Design Review Commission Report

Meeting Date: Monday, September 9, 2013
(Continued from Thursday, June 6, 2013)

Subject: **1006 Lexington Road (PL1307786)**
A request for an R-1 Design Review Permit to allow for construction of a new two-story single-family residence located in the Central Area of the City north of Santa Monica Boulevard. The Commission will also consider adoption of a Categorical Exemption, pursuant to the California Environmental Quality Act.

Project Applicant: Robert Hanasab – M & Y Management

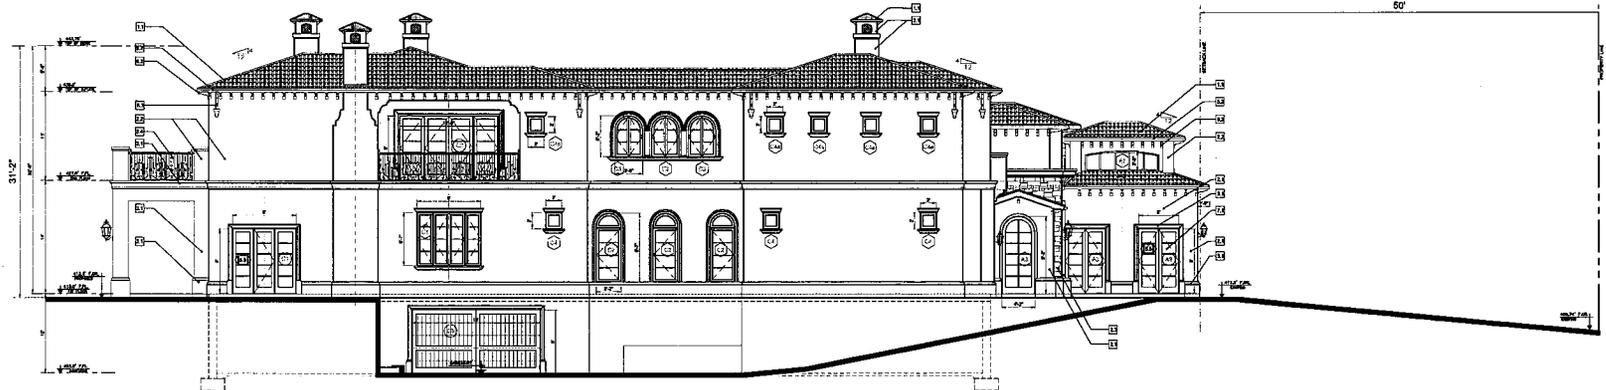
Upon review of the proposed design, staff has concern regarding the overall design of the proposed single-family residence. The following comments summarize the review conducted by staff:

- The number of elements proposed on the façade overwhelms the design. The materials and design elements should be fully reconfigured in a way to create internal compatibility.
- The proposed single-family residence is too bulky and massive and would not enhance the existing streetscape.

In order to adjust and unify the design, the following modifications have been made. The entire house is now one consistent color as opposed to two. The cornerstones and archways have been removed and substituted with straight entryways. The continuous band moulding is a light color and wraps around the house at a uniform height which breaks up the mass. The window frames are a deep brown and the multi-color roof tiles are deeper shades to complement the stucco and stone. Regarding comment on having too many exposed roof elements, one roof has been eliminated on the right side of the facade to balance the appearance of the house from the street. The entry gate has been simplified to straight wrought iron pickets. Through these changes the design has been simplified and projects a more uniform appearance.

DATE	JULY 2013
DRAWING TITLE	ELEVATIONS - SOUTH & WEST
SCALE	AS NOTED
JOB TITLE	POURSHAMTOBI RESIDENCE
JOB ADDRESS	1006 LEANINGTON RD. BEVERLY HILLS CA 90210
DRAWN BY	GD-JL;TEL;MM
OWNER/DEVELOPER	TORAG POURSHAMTOBI
JOB NUMBER	
SHEET NUMBER	A-5.1

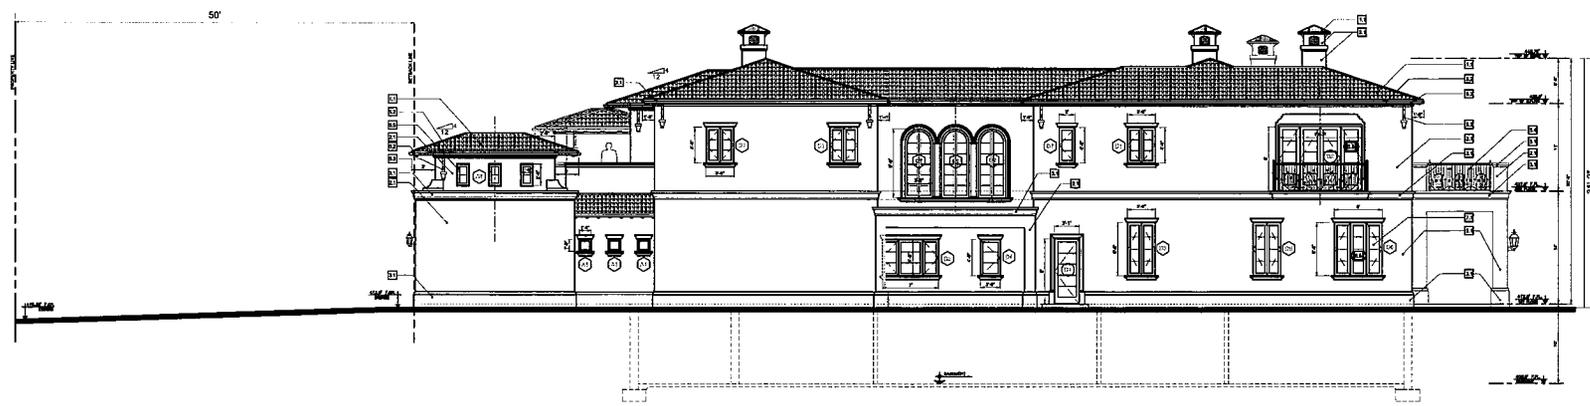
Based on a review conducted by the City's Urban Designer, the project has been simplified but the details need to be further revised for a more cohesive aesthetic. Specifically, the following elements were identified:

- The proportion of the front door is too tall and skinny. Consider reducing the total height of the entry element and re-proportion the door as appropriate.
- Removal of the discontinuous base molding at the bump up to the left of the entryway.
- Reduction in the overhang of the eaves at the bump up to the left of the entryway.
- Removal of the two small second floor windows above the bump up to the left side of the entryway to simplify that area of the façade.
- Removal of façade lighting except for the two proposed at the entryway.
- Removal of the chimney nearest the porte cochere to further balance the roof area.
